From: Peter Houk <xxxxxxxx@gmail.com>
Sent: Saturday, July 15, 2023 8:45 PM
To: Hess, Raymond <xxxxxxxx@a2gov.org>; Cespedes, Christopher <xxxxxxxx@a2gov.org>; City of Ann Arbor Transportation Commission <xxxxxxxx@a2gov.org>
Subject: crosswalk design guidelines

Greetings everyone. Following up from our last meeting, I put together some things that I think should be changed about our current crosswalk design guidelines.

Crosswalk Design Guidelines: Uncontrolled

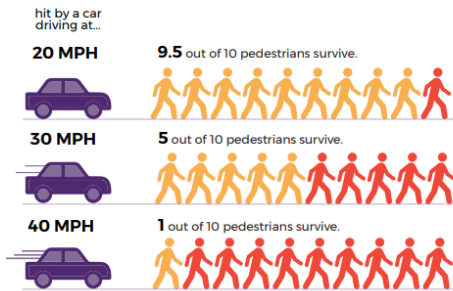
1. The [flow chart](#) references the NCHRP 562 worksheet and process. (For those unfamiliar with NCHRP 562, [here it is](#).) The inputs to the NCHRP worksheet are very precise (vehicle speed, volume, etc.) but the output of our crosswalk design flowchart is VERY open to interpretation. Choosing as few as 1 of the suggested design options complies with the guidelines.

- a. If we are trying to create a recognizable look/feel for all crosswalks throughout Ann Arbor, this is not the way to do it.
- b. Additionally--more options will equal more arguments between neighbors and staff about what is the right thing to do. A similar street near mine has a pedestrian refuge island, but mine doesn't...why not? Let's get approval for the guidelines at the administrator and council level. Then, if a resident has a complaint about a proposed implementation, they can take it up with their council member instead of endless arguments with engineering staff.

2. The guidelines are not specific enough about implementation. Example: RRFB is a potential treatment. Do we have RRFBs only at the curb? (Like [Stadium near Liberty](#)) Or are they above the middle lanes (like [Stadium at Pioneer](#) or [Plymouth at Willowtree](#)) or in the refuge island (like [Huron at Thayer](#))?

3. The guidelines have categories for "greater than or equal to 3 lanes" and "less than or equal to 3 lanes". So a 3 lane road could fit into either of those categories.
